Community Sounding Board Meeting Summary

Date: March 11, 2024	Time:	5:30 – 8:30 PM	
Location: Zoom	Topic:	Fishing, 5 th Avenue Bridge Experience, and Recreation

Proposed boardwalks in Middle Basin and South Basin

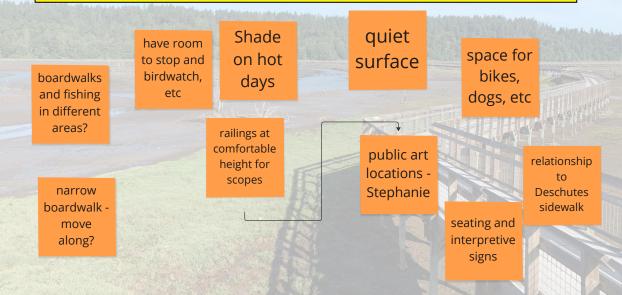
We have been assuming programming for boardwalks for passive use only. Should we be considering other programming, such as active uses like fishing?

How can we design the boardwalks in such a way that recreationalists feel safe? (lighting, emergency response, active uses like fishing, etc.)

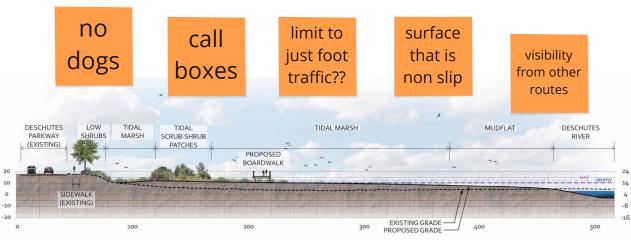
We have been assuming programming for boardwalks for passive use only. Should we be considering other programming, such as active uses like fishing?

if fishing designated areas only	plan for bikes - separate lanes?	2 bikes to pass?	not slippery	school groups - wider	
meander rather than linear	bump outs	birds - seasonal changing signs	no bikes - ped only	separate fishing piers east from board

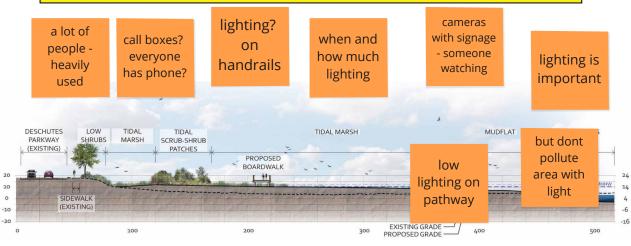
Would you use a boat launch in Marathon Park, and if so, when and what type of hand-carried vessel?

Echo - west bay park better location

Would like Marathon for kayak launch - parking

some will put in at tumwater and adventure down City of Olympia kayak concession at Marathon?

If a boat launch is programmed in Marathon Park, are there specific features that would make it more useable for a range of abilities?

lf ADA around Marathon optimal re: water levels? Multiple put-in and take-out locations

liability concerns re: people getting stuck
